**Identification cards — Contactless
integrated circuit(s) cards — Proximity
cards —**

**Part 3:
Initialization and anticollision**

**AMENDMENT 3: Handling of reserved fields
and values**

Amendment 3 to ISO/IEC 14443-3:2001 was prepared by Joint Technical Committee ISO/IEC JTC 1, *Information technology*, Subcommittee SC 17, *Cards and personal identification*.

Figure 25 — Protocol Info format

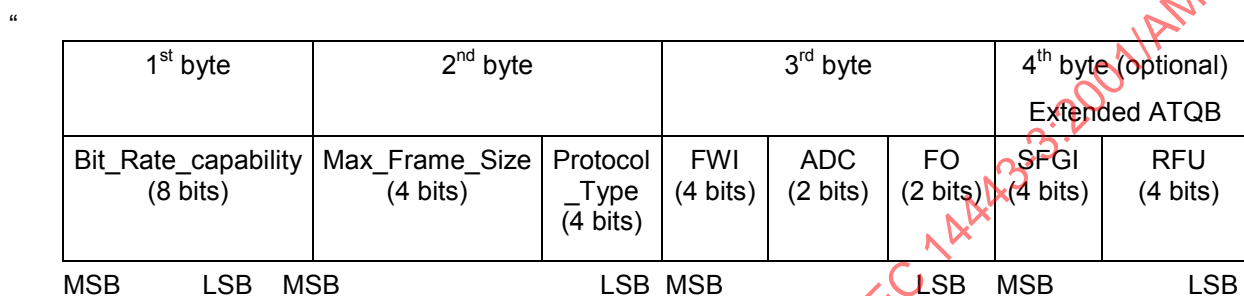
Page 32, Subclause 7.9.4 "Protocol Info"

Replace figure 25 with the following figure:
